# SERVICE BULLETIN

No. 527

Piper Aircraft Corporation

Electric Trim Switch Modification

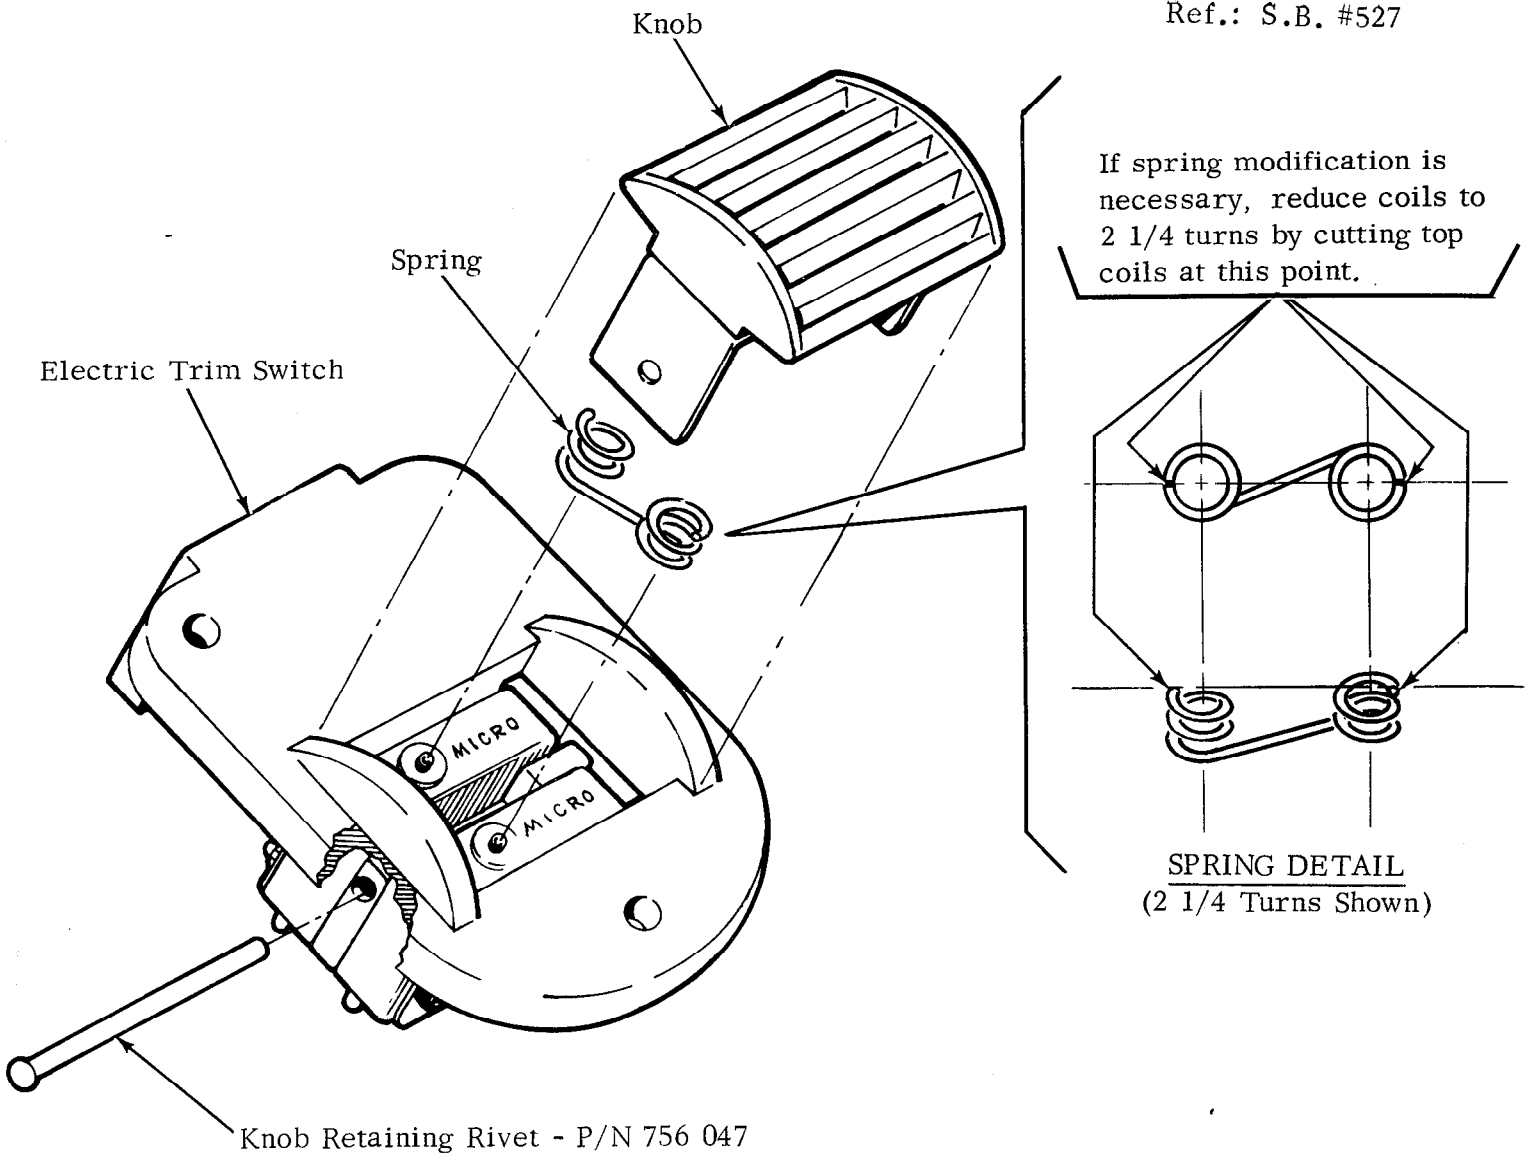
Purpose: Field reports describe a condition wherein the pilot's control wheel mounted "rocker" type electric trim switch tends to "hang up" in the "FWD"/"NOSE UP" or "AFT"/"NOSE DOWN" mode; i.e., fails to return to the "neutral" position following removal of thumb pressure. This condition occurred on some aircraft modified in accordance with Service Bulletin No. 331. Subsequent investigation revealed that the switch return coil springs supplied with Piper Kit No. 760 505 (Electric Trim Switch Modification), per Service Bulletin No. 331 and subsequent production modified models--for a period of time--had an excessive number of coils, which may cause the end of the coil spring to become caught between the switch "rocker" actuator and the micro switch body, thus preventing spring assisted return of the switch to "neutral".

To remedy--and prevent--this condition, this service release provides instructions to modify the electric trim switch return spring by reducing the number of coils (from 2 1/2 turns to 2 1/4 turns--reference attached sketch/instruction sheet for an illustrated view of this condition).

4. Remove knob and spring from switch.
5. Inspect spring to determine if coils consist of 2 1/4 turns as shown in above detail or 2 1/2 turns.
  - a. If coils consist of 2 1/4 turns, proceed to Step 6.

- b. If coils consist of 2 1/2 turns, modify spring by cutting 1/4 turn from top of coils before proceeding to Step 6. Refer to spring detail above.
6. Place spring (P/N 757 685 - Scott #10004324) over micro-switch buttons with open ends of spring facing up. Spring coils must be concentric with micro-switch buttons and shoulders, and must not rest upon them.
